**Comprehensive Transportation Corridor Study and Plan for NM502**  
**Public Questions and Staff/Consultant Responses in *Italics***  
**6.23.2011**

Chapter 3 (cont.):  
Updated planning-level capacity figure

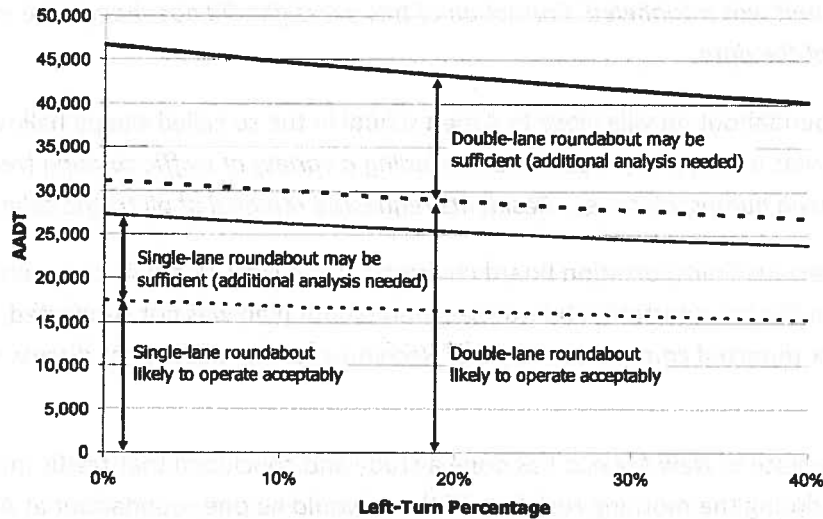
- N10. ADT graphic used in the 5/24 staff PowerPoint presentation has such a wide range of capacity for a single lane round-a-bout. Ron had another piece of published data that had 15,000 as the capacity of a single lane round-a-bout and you must know the size of the round-a-bout to know the capacity.

*This is a planning level capacity analysis diagram. Up to about 18,000 AADT, depending on left turn percentages, a single lane roundabout is likely to operate. At more than 18,000 AADT, a single lane roundabout may be sufficient.*
